**B&W Nuclear Environmental Services, Inc.**

March 23, 1994

The B&W Nuclear Environmental Services, Inc., Lynchburg Technology Center is requesting an amendment to our license, SNM-778, to incorporate organizational changes and to increase one of our possession limits which will allow us to save considerable money on transportation costs.

DEMONSTRATION AND CONDITIONS  
FOR LICENSE SNM-778

FIGURE 2-1  
SITE ORGANIZATION

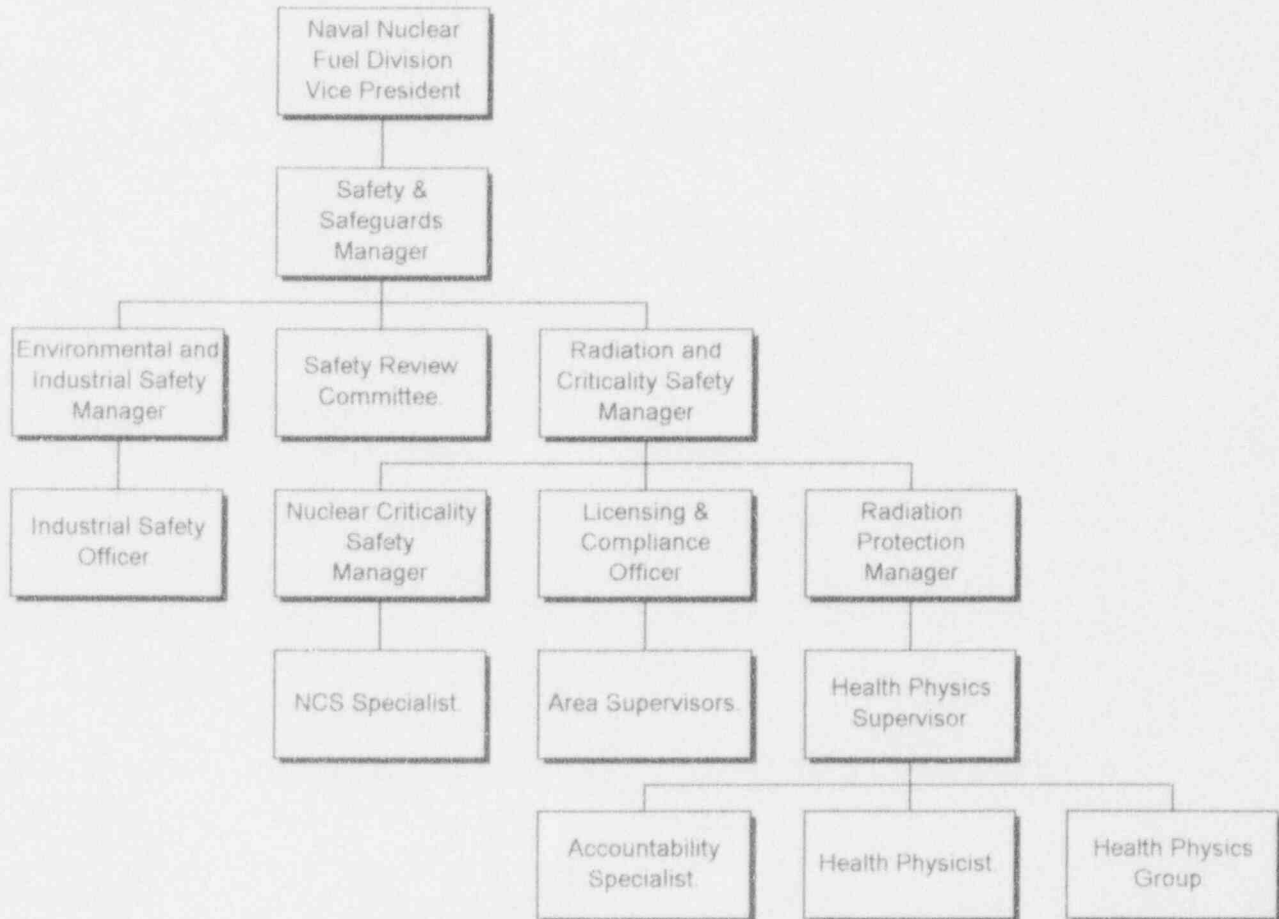
A new organization chart has been provided.

FIGURE 11-1

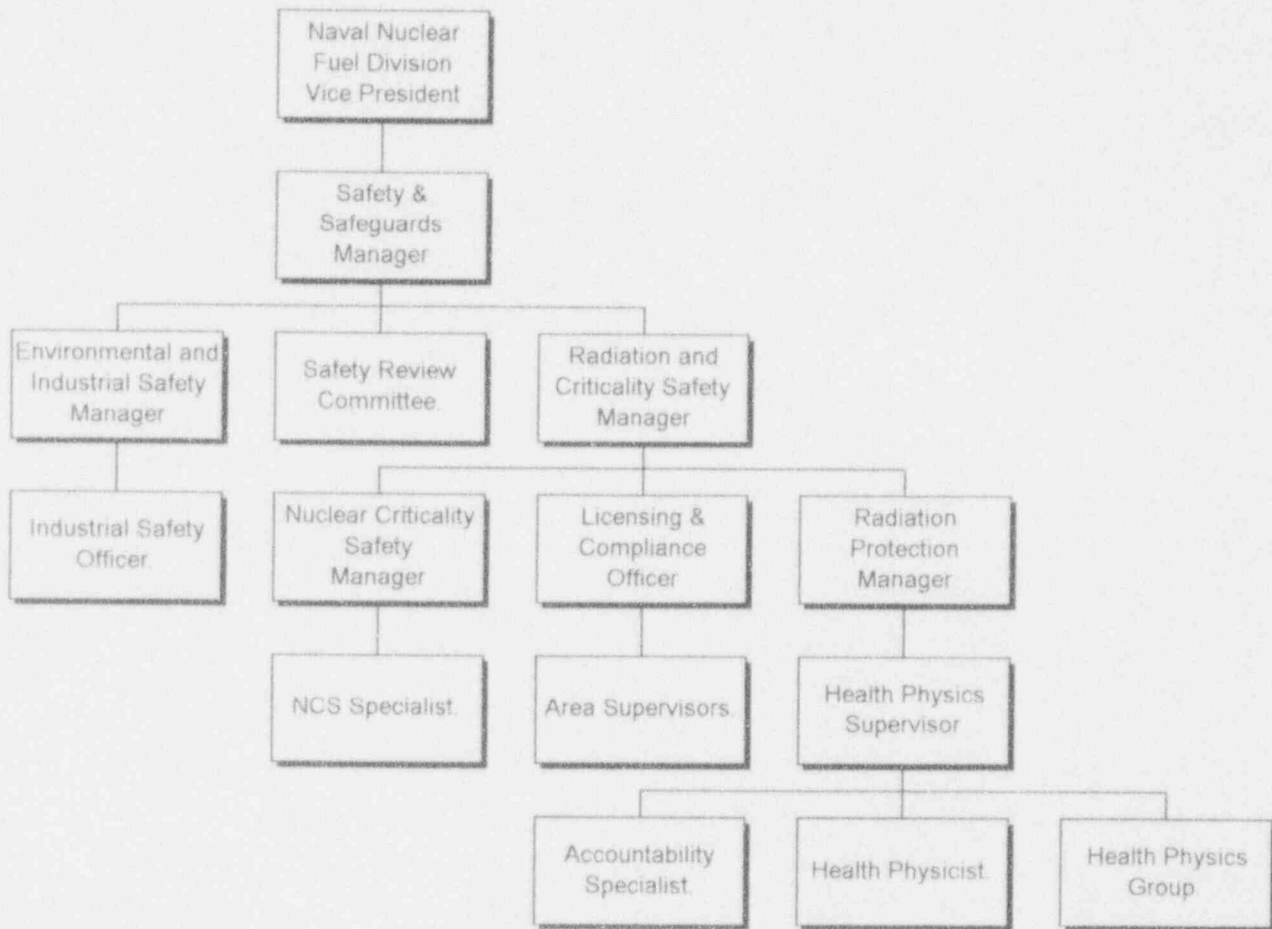
A new organization chart has been provided.
